## **An Bord Pleanála Oral Hearing**

**Greater Dublin Drainage**

**Response to Roads Issues Raised on behalf of Gannon  
Properties and Response to Roads and Traffic Issues Raised  
by Sabrina Joyce Kemper**

***(27<sup>th</sup> March 2019)***

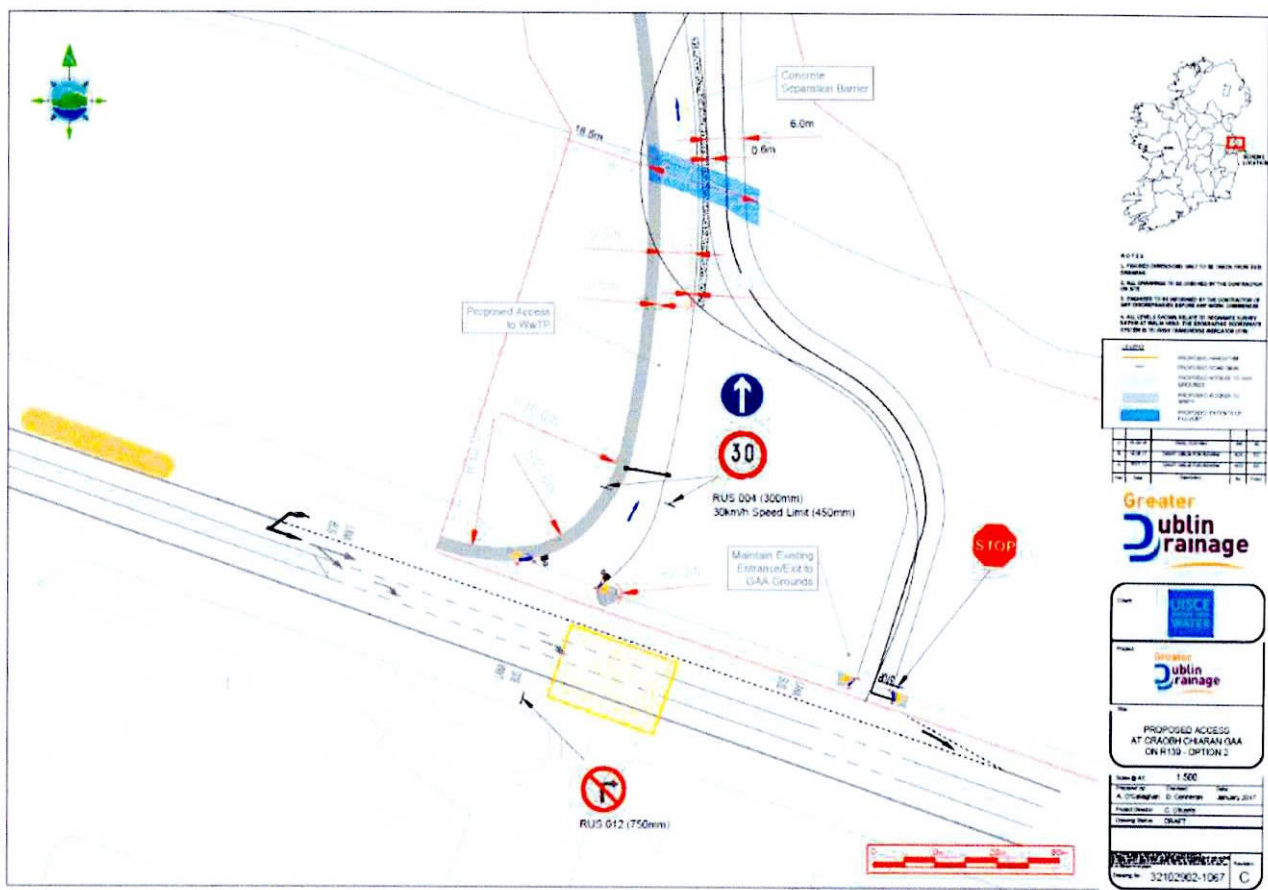
- 11 The observer has stated the applicant be conditioned to construct the Mayne River Culvert to the distributor road standard.
- 12 I can confirm that the application for the Proposed Development includes the construction of the Mayne River Culvert to facilitate both the proposed one-way WwTP Access Road and the adjacent Craobh Chiaráin GAA club access road proposals. This is shown as the blue hatched area on drawing 32102902-1067 included with Appendix 2 - Appendix A Part 2 of the Construction Environmental Management Plan.

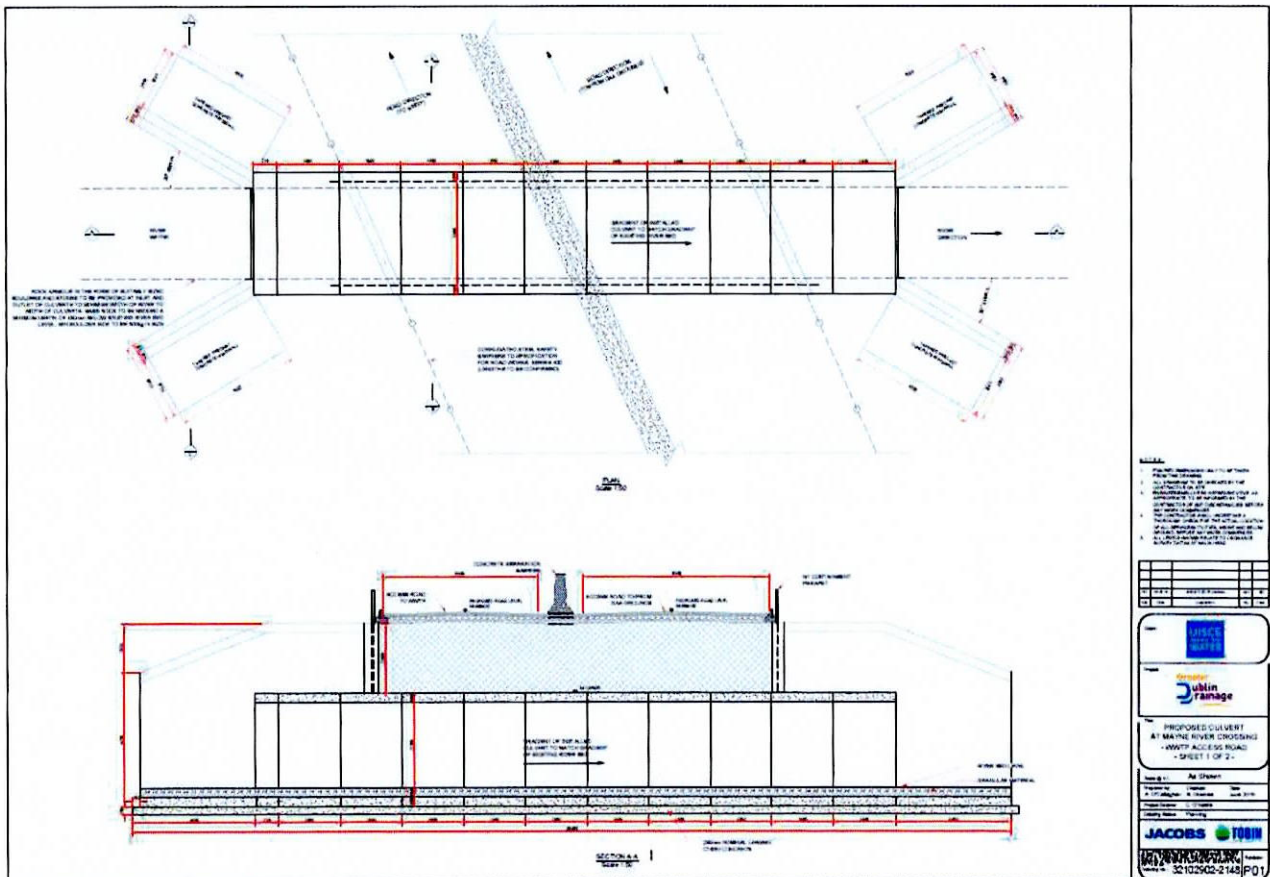
- 13 The length of the proposed Mayne River culvert shown on Planning Drawing 32102902-2148 will also facilitate the indicative cross section of the FCC future North South Link Road (i.e. 17.5m wide back of footway to back of footway, comprising 2m footway, 1.5m on road cycle lane, 3.5m northbound traffic lane, 3.5m reserve / turning lane, 3.5m southbound traffic lane, 1.5m cycle lane and 2.0m footway).
- 14 It is acknowledged that as the future North-South Link Road cross section is indicative, the future road width may be subject to change as the development plan is advanced. Should a wider future road cross section be required, the culvert can be widened by removing the eastern headwall and extending the culvert units the necessary additional width.
